Item Name: Lower Cutter Assy

ENGINEERING CHANGE NOTICE NO.		02195		SHEET 1 OF 4	
DWG NO.	646.3000	REV: N/C	PREPARED BY	S. HUFF	DATE: 01/05/09
DWG TITLE:		LOWER CUTTER ASSY			
APPROVED BY:	ENGR <i>[Signature]</i>	MFG	<i>[Signature]</i>	QC	<i>[Signature]</i>
TRANSACTION CODES (TC): A-ADD C-CREATE R-REVISE D-DELETE		REASON: REMOVED RIVETS IN FAVOR OF ADDITIONAL SCREWS			
		EFF:		NEXT ORDER

SHEET 1, ZONE D5, IS:

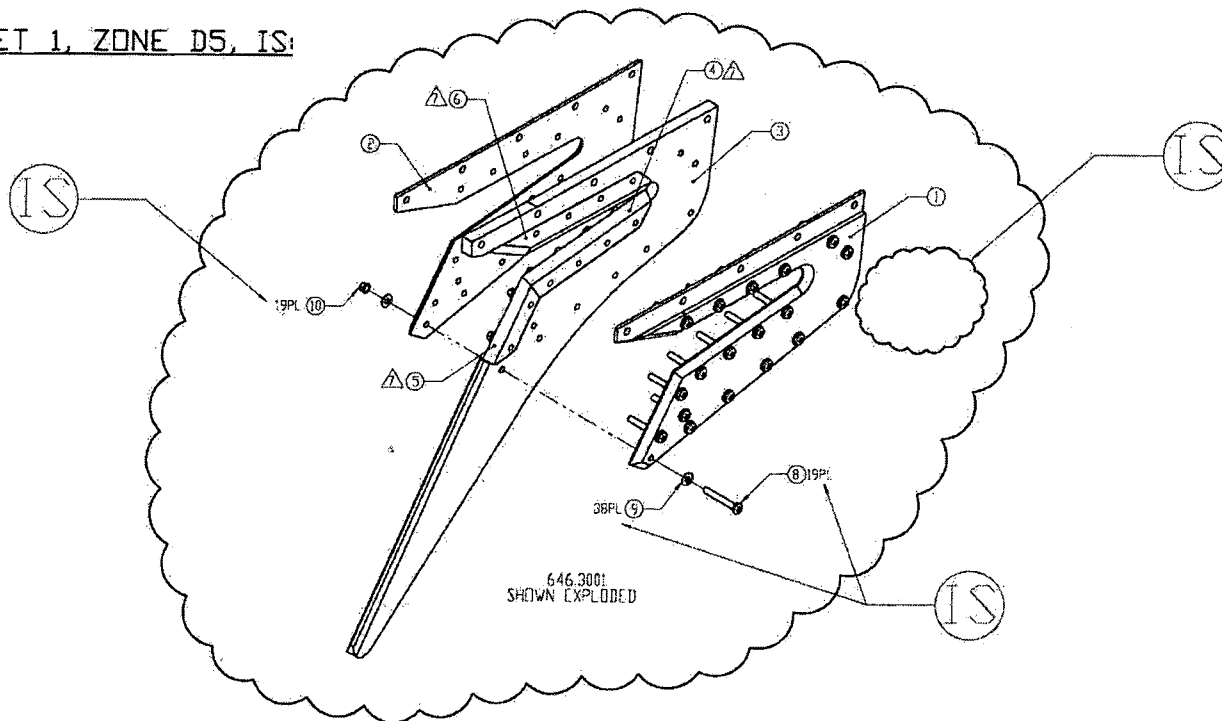
10	R	601.1541	19	LOCKNUT	MS21042L08
9	R	601.2764	38	WASHER	NAS1149FN832P
8	R	601.2765	19	SCREW	MS27039-0819
7	D	601.2766	2	RIVET	MS20470AD5-18
			.3001		
F/N	TC	PART NUMBER	QTY	DESCRIPTION	MATERIAL/SPECIFICATION
DOCUMENTS EFFECTED:				CHANGE CATEGORY	DER REVIEW REQUIRED
☐ MDL ☒ INSTALL INSTRUC ☒ ICA ☐ FMS ☒ BOM				☐ MAJOR ☒ MINOR	☐ YES ☒ NO
